**BROWNS FERRY NUCLEAR PLANT (BFN) - UNIT 1 - SUPPLEMENT TO  
TECHNICAL SPECIFICATIONS (TS) CHANGE 428 - UPDATE OF PRESSURE-  
TEMPERATURE (P-T) CURVES**

This letter supplements proposed Technical Specification (TS) 428, which revises the reactor vessel P-T limit curves.

ENCLOSURE  
BROWNS FERRY NUCLEAR PLANT, UNIT 1  
TECHNICAL SPECIFICATION CHANGE REQUEST (TS 428)  
UPDATE OF PRESSURE-TEMPERATURE (P-T) CURVES

**Figure 3.4.9-1**  
**Pressure/Temperature Limits for**  
**Mechanical Heatup, Cooldown following Shutdown, and**  
**Reactor Critical Operations**

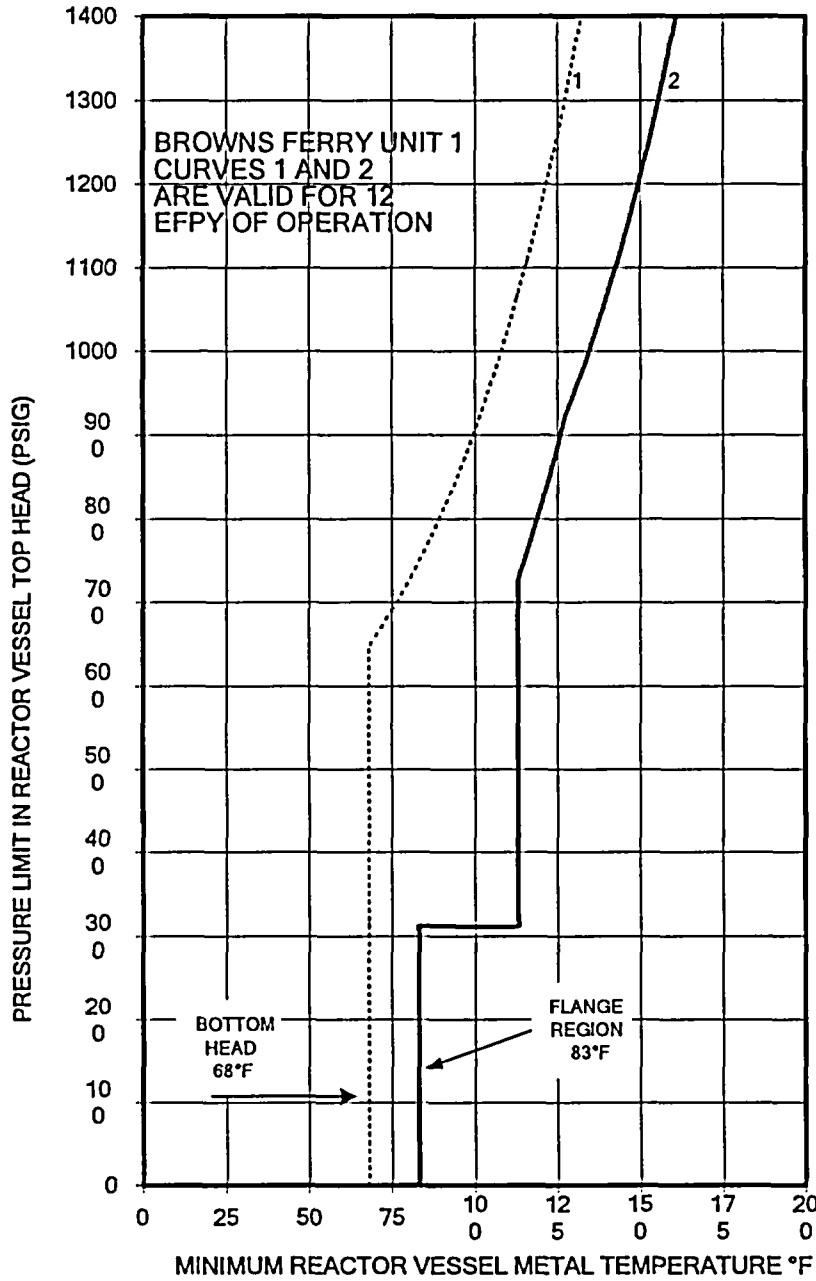
TVA identified a typographical error on the mark-up and clean TS pages 3.4-29 and 3.4-29a. The notes on these pages should have referenced 12 Effective Full Power Years (EFPY) instead of 16 EFPY. Updated pages are enclosed with this submittal.

Notes  
These curves include sufficient margin to provide protection against feedwater nozzle degradation. The curves allow for shifts in  $RT_{NDT}$  of the Reactor vessel beltline materials, in accordance with Reg. Guide 1.99 Rev. 2 to compensate for radiation embrittlement for 12 EFPY.
